The yellow highlighted comments from Electrical Engineer, which needs to be included in DFC. Next sheet is latest Output DFC file

Project:
MOBILE NETWORK AUSTRALIA
SITE No:- H8031
SNUG
120 LONGMANS ROAD

Drawing Title:
SITE LAYOUT AND SETOUT PLAN

Drawing No. H8031-G3

DETAIL 1/G2
SCALE 1:100

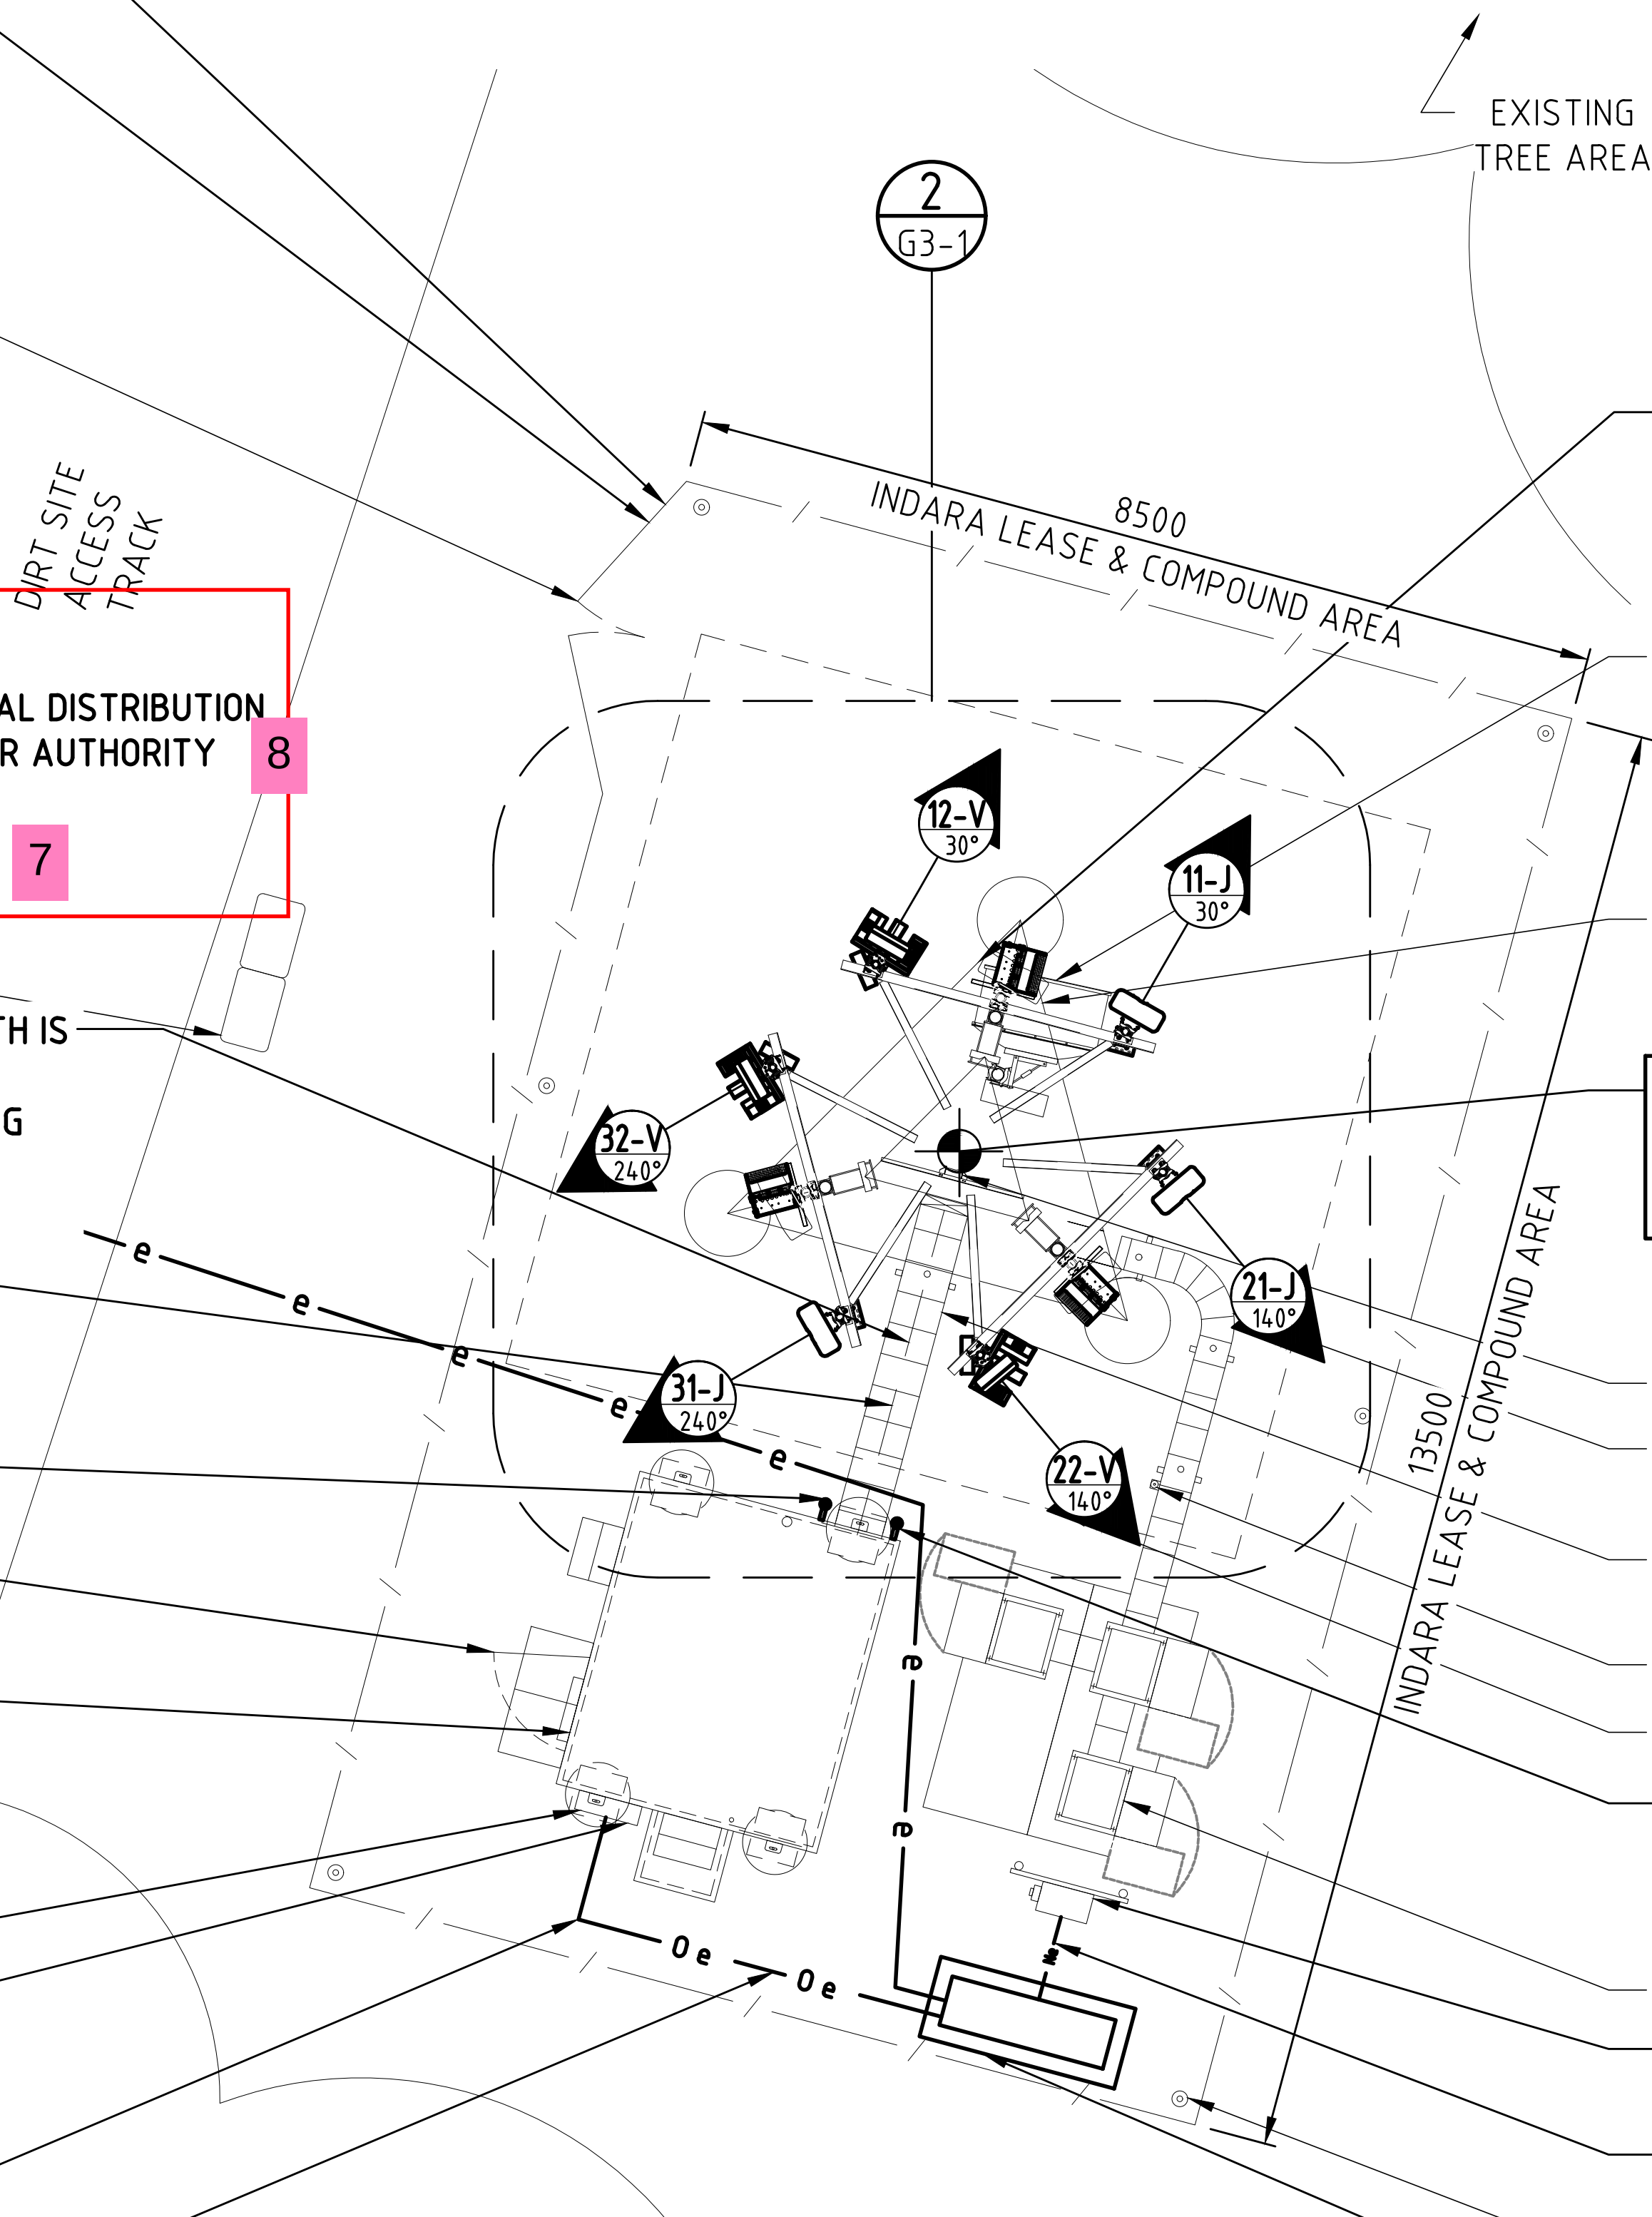
EXISTING OVERHEAD LOW VOLTAGE ELECTRICAL DISTRIBUTION MAINS CABLE TO BE UPGRADED BY THE POWER AUTHORITY 8

NEW UNMETERED ELECTRICAL LOW VOLTAGE ELECTRICAL CONSUMERS MAINS CABLE (REFER SHEET H8031-E1 & E2 FOR DETAILS) 7

6 EXISTING OPTUS METER PANEL TO BE CONVERTED TO AC DISTRIBUTION BOARD (REFER SHEET E1 & E2 FOR DETAILS)

5 EXISTING OPTUS UNDERGROUND CONSUMERS MAINS CABLE TO BE RECOVERED

4 NEW OPTUS UNDERGROUND LOW VOLTAGE ELECTRICAL SUBMAINS CABLE (REFER SHEET H8031-E1 & E2 FOR DETAILS)

EXISTING NBN PDB/METERING PANEL ON H-FRAME SUPPORT TO BE CONVERTED TO AC DISTRIBUTION BOARD 1

NEW NBN UNDERGROUND LOW VOLTAGE ELECTRICAL SUBMAINS CABLE (REFER SHEET H8031-E1 & E2 FOR DETAILS) 2

NEW 300A RATED CONCRETE PLINTH MOUNTED ELECTRICAL MAIN SWITCH BOARD (REFER SHEET H8031-E1 & E2 FOR DETAILS) 3
